RE: Pending modification to FCC ID **LX698FC4007**

Per our conference call dated, May 12, 1999; concerning the file **LX698FC4007**.

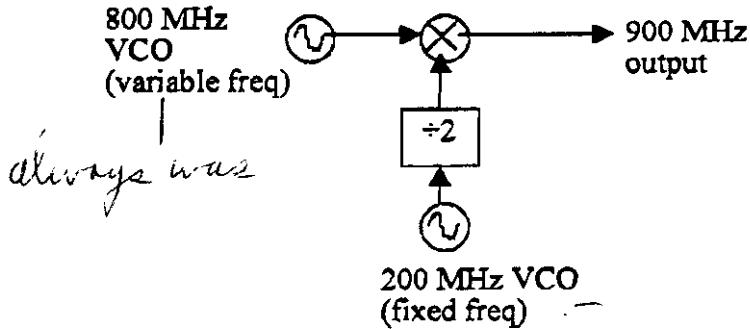
The subject Transmitter consists of two VCO's as shown in the block diagram below.

The basic frequency determining VCO was not changed. The 200 MHz VCO originally used was made obsolete by the vendor, thereby requiring a new VCO. A new VCO with similar performance specification was chosen to replace the obsolete part. Note that all other circuitry, such as the frequency determining VCO, both synthesizers, mixer, and divider circuitry were NOT changed. Any change in the frequency of the subject transmitter is performed by changing the frequency of the 800 MHz VCO, and this has not changed from the original design.
